Groundwater Remedy Phase 2A Construction, PG&E Topock Compressor Station, Needles, California

Work Variance Request #12 – Proposed addition of pipelines/conduits to connect existing extraction well TWB-3 and deferral of the Operations Building on the Transwestern Bench

Variance Request No.: 12

MICROFILM	
BILL OF MATL	
DWG LIST	
SUPSDS	
SUPSD BY	
SHEET NO.	of SHEET
C-07-106	REV 10

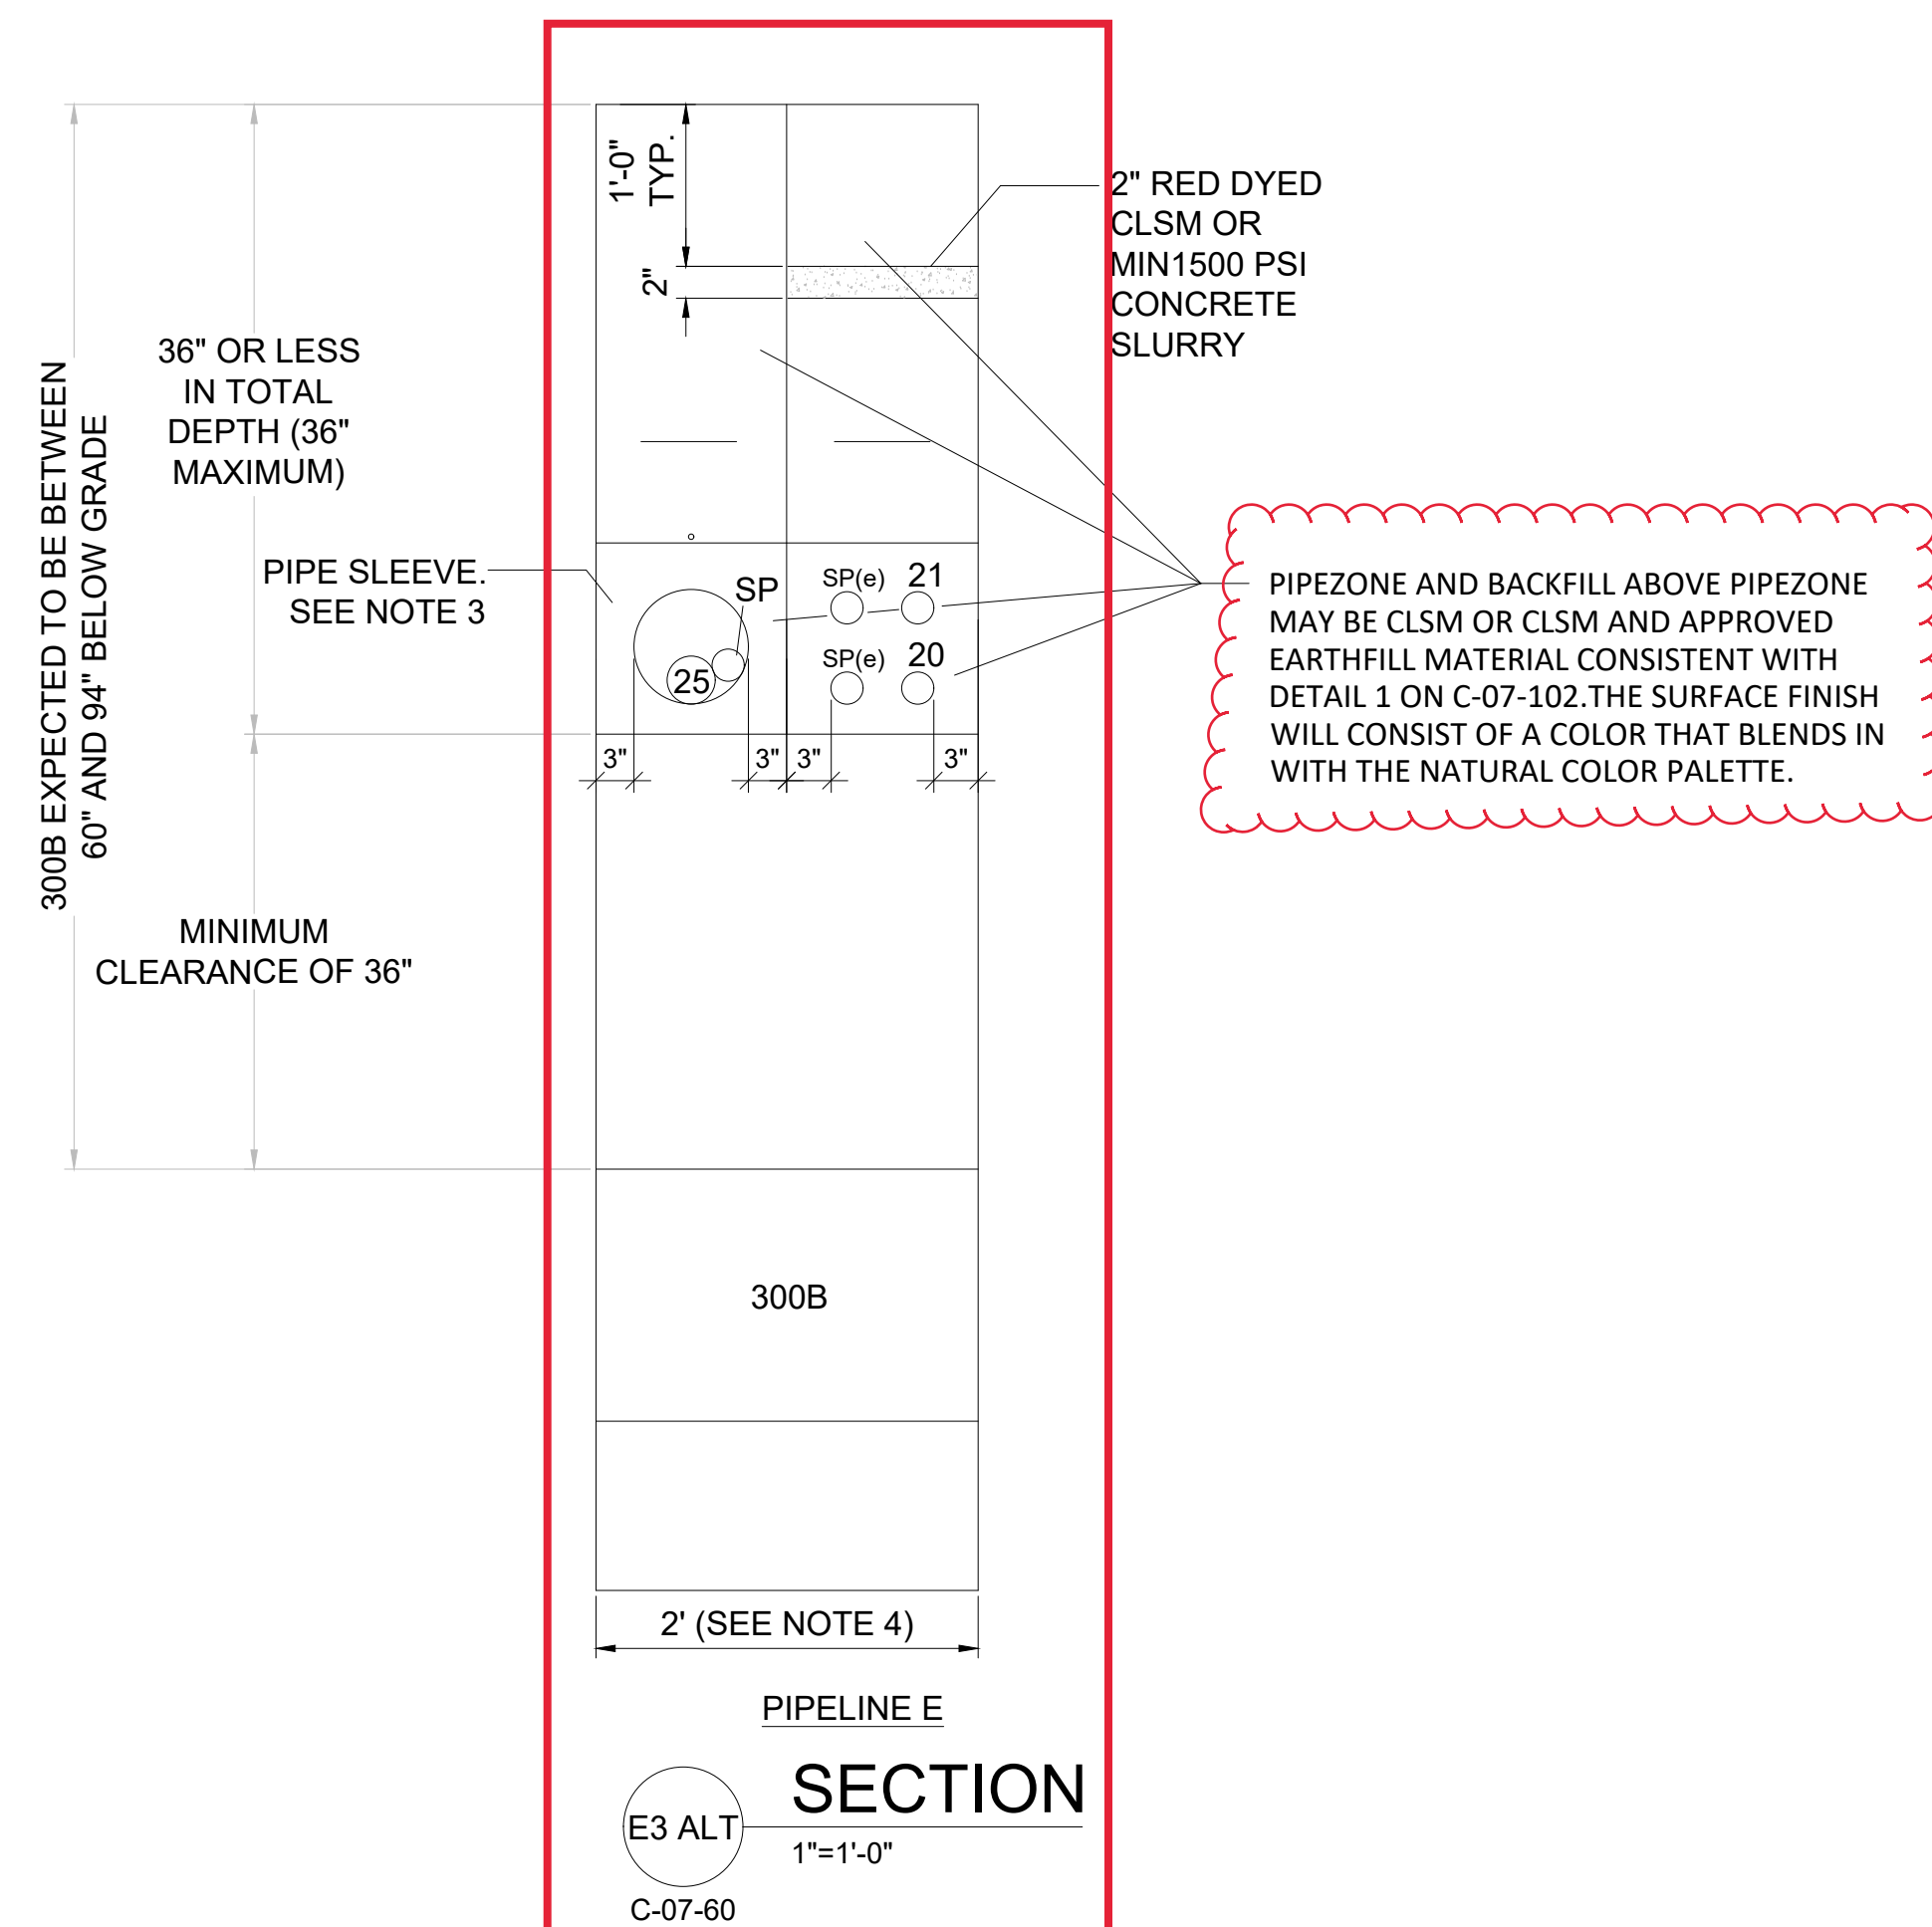
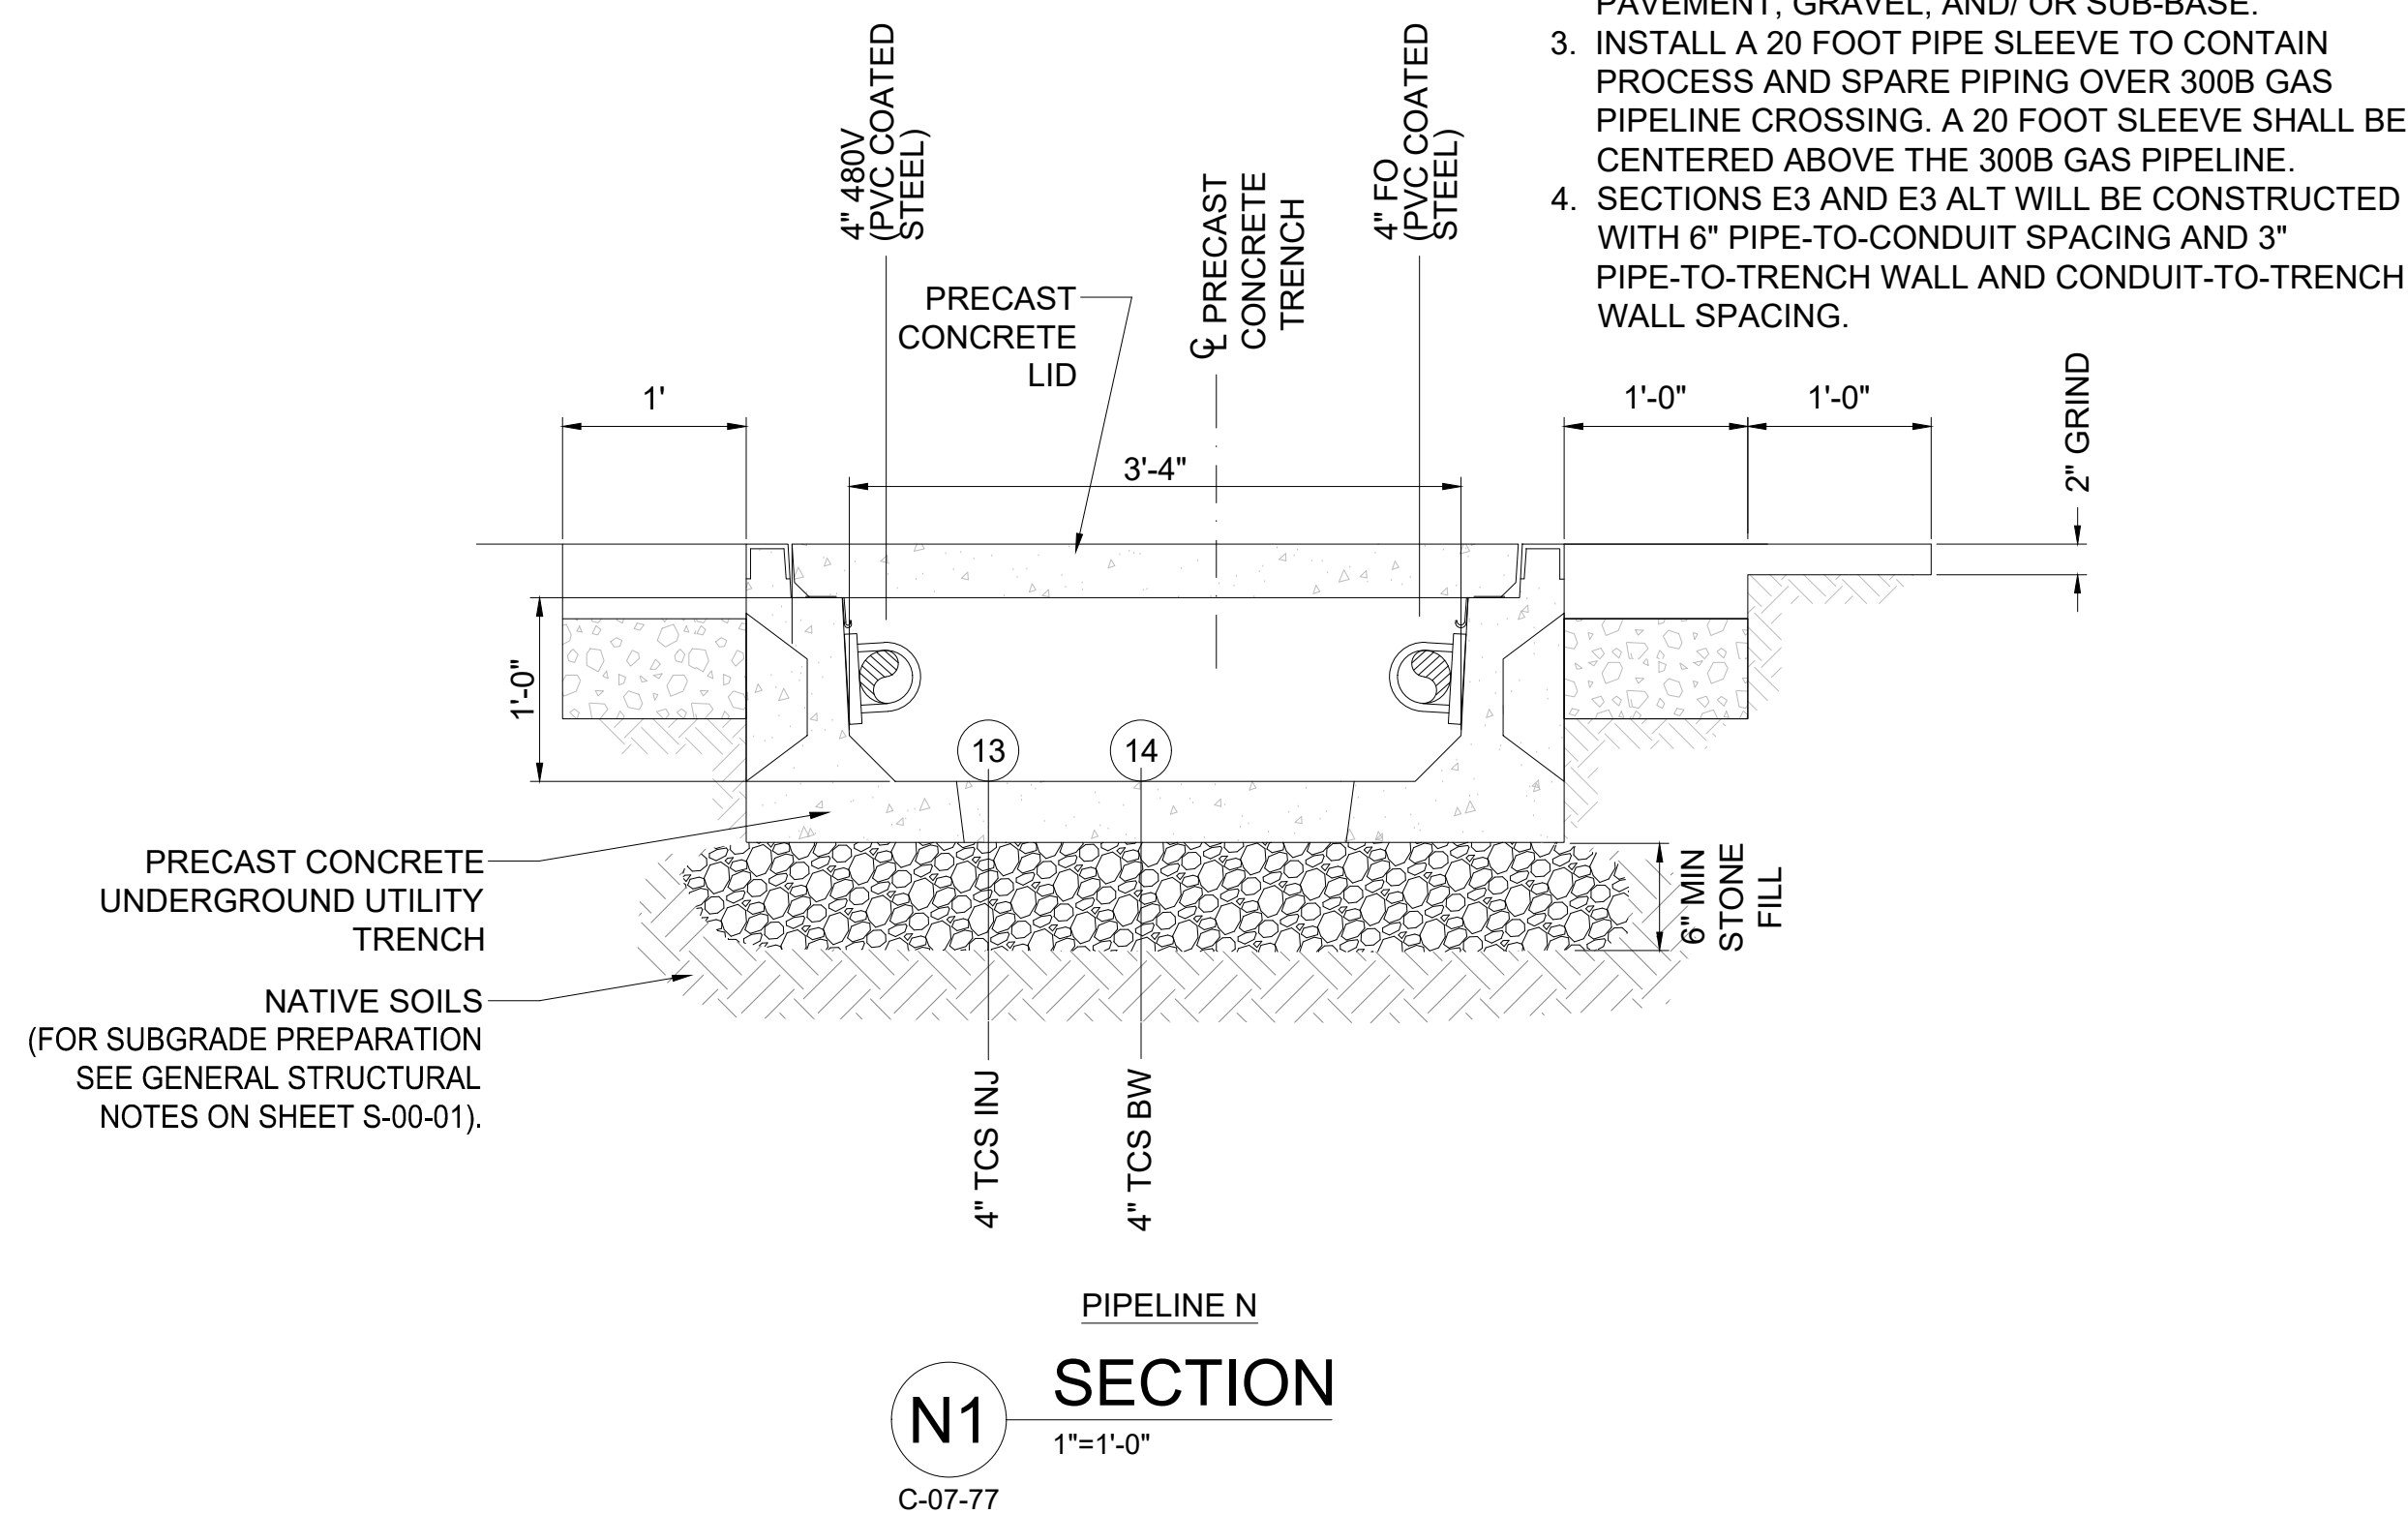
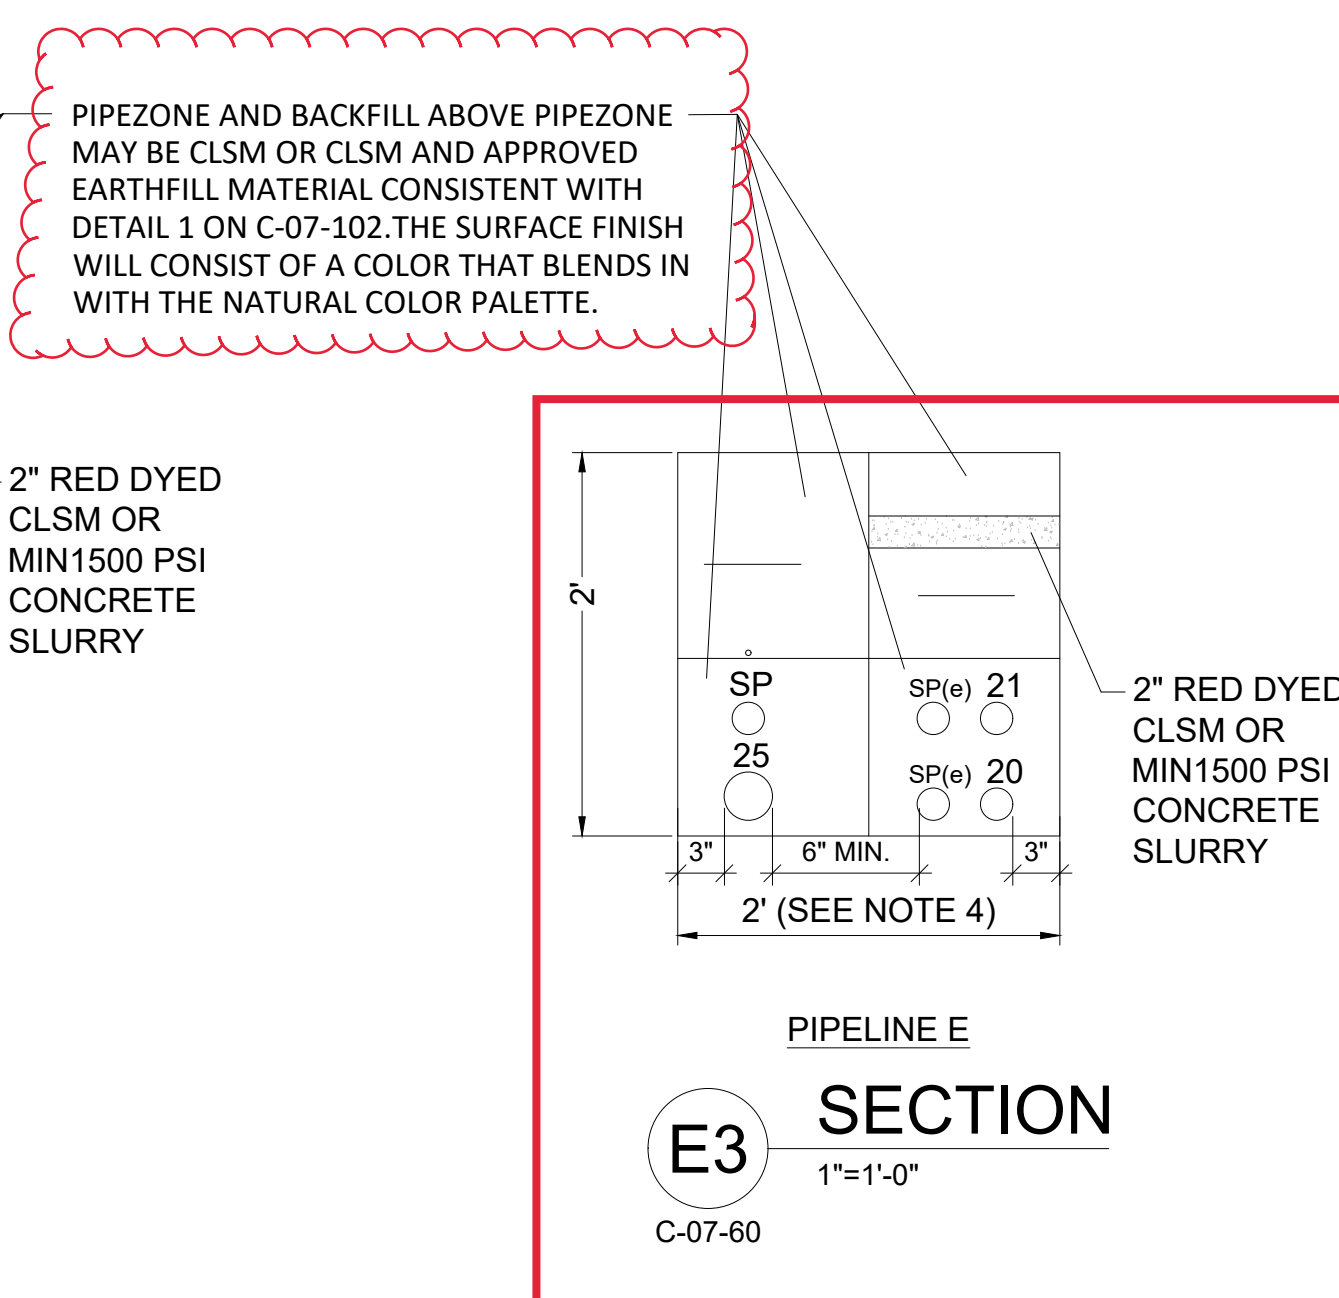
The plan and profile of the new pipeline is shown in the attached drawing C-07-60. The trench sections E3 and E3-Alt are shown in attached drawing C-07-106. Below is a summary of key construction details:

- A trench of approximate dimension of 2 feet wide by 3 to 4 feet deep by 470 feet long will be installed from existing well TWB-3 to existing well TWB-1. The actual dimension of the trench may vary depending on field conditions.

- Within the trench, there will be two High Density Polyethylene (HDPE) pipes (2 or 3 inches in diameter by 470 feet long) and three conduits (2 inches in diameter by 470 feet long). Where the trench crosses over PG&E gas pipeline, one pipe sleeve (approximately 4 inches in diameter by 20 feet long, actual dimension may vary depending on field conditions) will be used to contain the HDPE pipes. Therefore, the total pipe length is $2 \times 470 + 1 \times 20 = 960$ feet and total conduit length is $3 \times 470 = 1,410$ feet.
